Project	IEEE 802.16 Broadband Wireless Access Working Group < http://ieee802.org/16 >	
Title	Bandwidth Request for Distributed Systems	
Date Submitted	2007-03-05	
Source(s)	Masato Okuda and Yuefeng Zhou Fujitsu	okuda@jp.fujitsu.com Yuefeng.Zhou@uk.fujitsu.com
	I-Kang Fu, Fang-Ching Ren, Chie-Ming Chou NCTU/ITRI 1001 Ta Hsueh Rd, Hsinchu, Taiwan, R.O.C.	IKFu@itri.org.tw
	Kenji Saito KDDI R&D Laboratories Inc.	Voice: +81 46 847 6347 saito@kddilabs.jp
	Shulan Feng, Yanling Lu, Ting Li, Liangliang Zhang Hisilicon Technologies Harbour Building, No.8, Dongbeiwang West Road, HaiDian District, Beijing, China	Voice: 86-10-82829010 Fax: 86-10-82829075 luyanling@hisilicon.com fengsl@huawei.com
Re:	IEEE802.16j-07/007r2: "Call for Technical Comments and Contributions regarding IEEE Project 802.16j"	
Abstract	This contribution proposes a distributed bandwidth request and allocation mechanism.	
Purpose	To propose text to describe a distributed bandwidth request and allocation mechanism

Bandwidth Request for Distributed Systems

Figure X-1 Relay Bandwidth Request Header Format

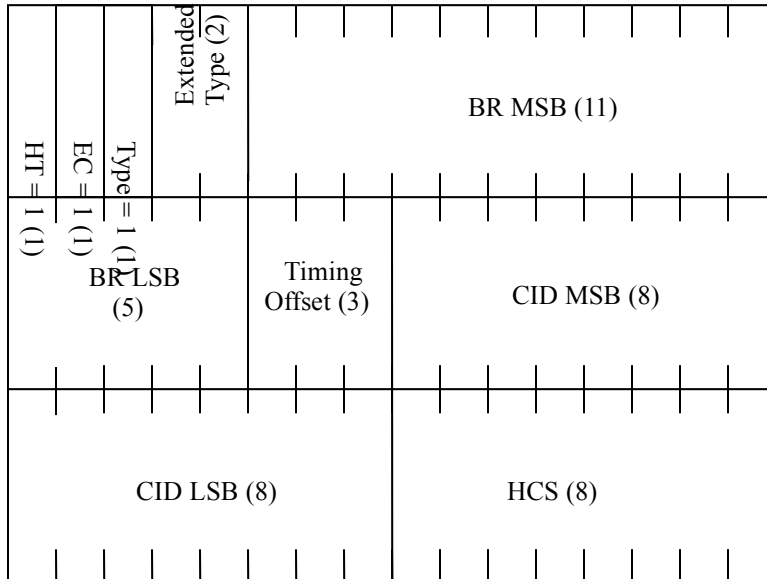
[Insert the following subclause at the end of 6.3.2.1.2.2:]

[6.3.2.1.2.2.2 Extended MAC Signaling Header Type II](#)

[This type of MAC header is UL specific. There is no payload following the MAC header. The Extended MAC signaling header type II is illustrated in Figure X-1. Table X-1 describes the encoding of the 3-bit extended type field following the type field.](#)

Table X-2— Description of fields in Relay Bandwidth Request header

Name	Size	Description
<u>BR</u>	<u>16 bits</u>	<u>Bandwidth Request: The number of bytes of uplink bandwidth requested by the RS (unit of 4-Byte). The bandwidth request is for the CID. The request shall not include any PHY overhead.</u>
<u>Timing Offset</u>	<u>3 bits</u>	<u>Time (in units of a frame) the receiver shall wait before allocating bandwidth corresponding to this header.</u>
<u>CID</u>	<u>16 bits</u>	<u>The CID shall indicate the connection for which uplink bandwidth is requested.</u>
<u>HCS</u>	<u>8 bits</u>	<u>Header Check Sequence (same usage as HCS entry in Table 5).</u>
